Proposed Policy Revisions

1. **Construction Reactor Oversight Process (cROP)**

(b) New flow chart and table for violation example 6.13.

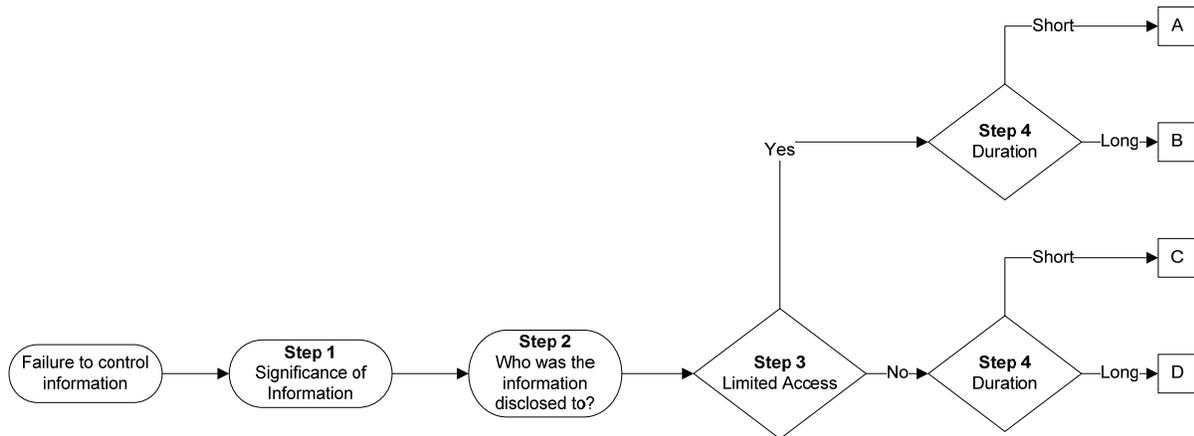
The staff is proposing to revise Section 6.13, “Information Security.” This revision will replace the current examples, which are based on the classification levels of the information, with a risk-informed approach for assessing the significance of information security violations. This approach of evaluating the significance of information security violations by using a risk-informed process is based on the actual or potential

This proposed process is the result of lessons learned from a number of violations that the NRC has processed over the last few years based on varying significance levels. This process will use a flow chart and table approach, along with defined terms.

Once a noncompliance is identified, a four-step approach will be applied to determine the significance level. The four steps are: (1) determine the significance of the information (i.e., high, moderate, or low), (2) determine the extent of disclosure (i.e., individual deemed trustworthy and reliable, unknown disclosure, or confirmed to an unauthorized individual), (3) determine the accessibility of the information (i.e., how limited was access to the information), and (4) determine the duration of the noncompliance (i.e., how long was the information available).

Once all steps are completed, the user will obtain a recommended severity level for the violation. The staff recognizes this approach as a change from the traditional violation examples; however, the new process will be risk-informed and will consider the significance of the information as it relates to public health and safety or the common defense and security regardless of the classification level. The proposed changes are located in Sections 4.3 and 6.13.

Step 2 Disclosure		Disclosed to an individual deemed Trustworthy and Reliable				Unknown Disclosure				Confirmed to an Unauthorized Individual			
		A	B	C	D	A	B	C	D	A	B	C	D
Step 1 Significance	High	SL III	SL III	SL III	SL II	SL III	SL II	SL II	SL II	SL II	SL II	SL II	SL II
	Moderate	SL IV	SL III	SL III	SL III	SL IV	SL III	SL III	SL III	SL III	SL III	SL III	SL III
	Low	SL IV	SL IV	SL IV	SL III	SL IV	SL IV	SL IV	SL III	SL III	SL III	SL III	SL III
